REMEDIAL SITE ASSESSMENT DECISION - EPA FORM IX

Site Name: Jervis B. Webb Co.

WORKPLAN FOR SOIL CLOSURE AND ADDENDUM TO WORKPLAN FOR SOIL CLOSURE – JERVIS B. WEBB COMPANY – 5030 FIRESTONE BOULEVARD, SOUTH GATE (SLIC NO. 744)

QUARTERLY GROUNDWATER MONITORING REPORT – JERVIS B. WEBB COMPANY – 5030 FIRESTONE BOULEVARD, SOUTH GATE (SLIC NO. 744)

Figure 1

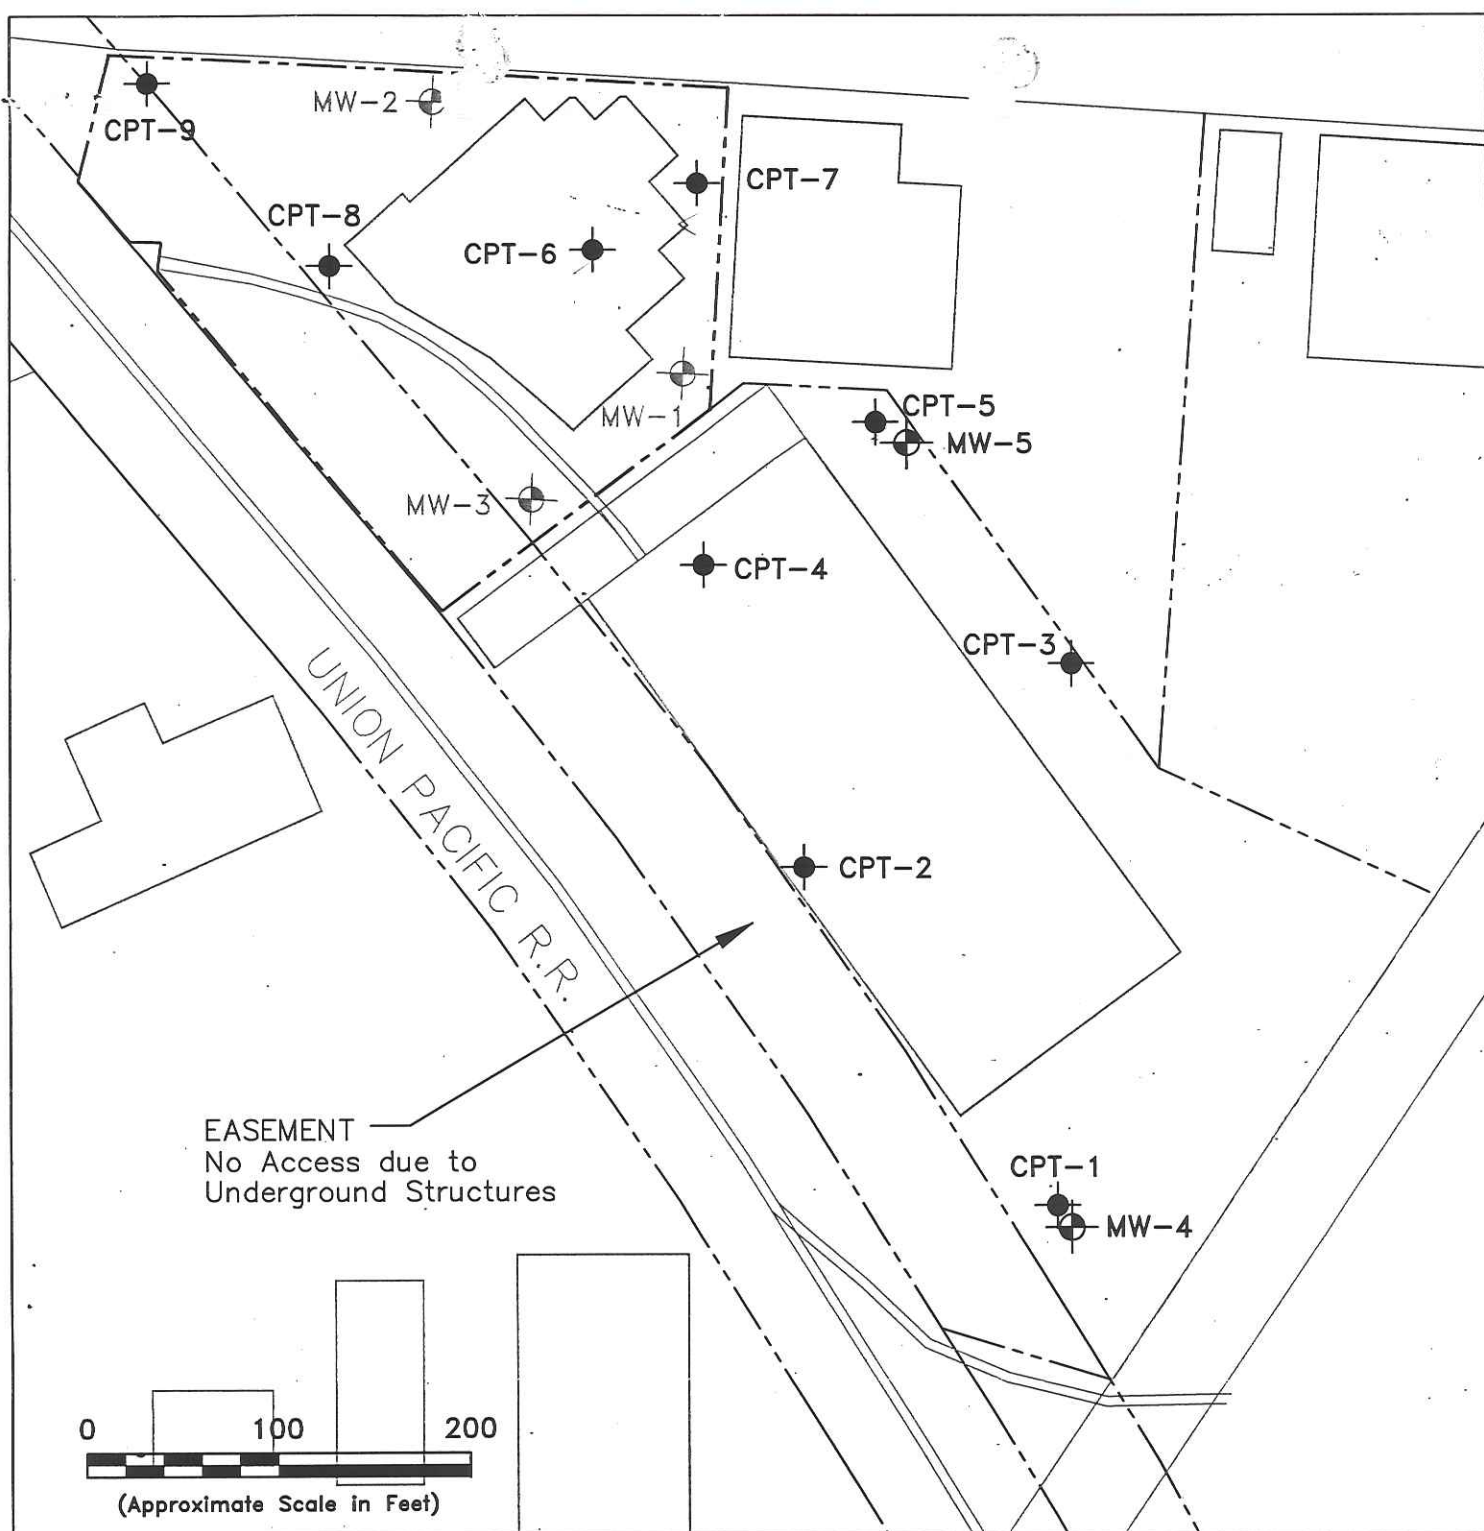
We propose to install two new groundwater monitoring wells on the Reliable Steel property. The proposed locations of these wells are shown on Figure 1. In accordance with the California Regional Water Quality Control Board, Los Angeles Region ("RWQCB") letter to Webb dated 4 September 1998, one well (MW-4) will be installed at the south end of the groundwater investigation area, near Rayo Avenue. We also propose to install a well (MW-5) at the northeastern corner of the Reliable Steel Property (see Figure 1).
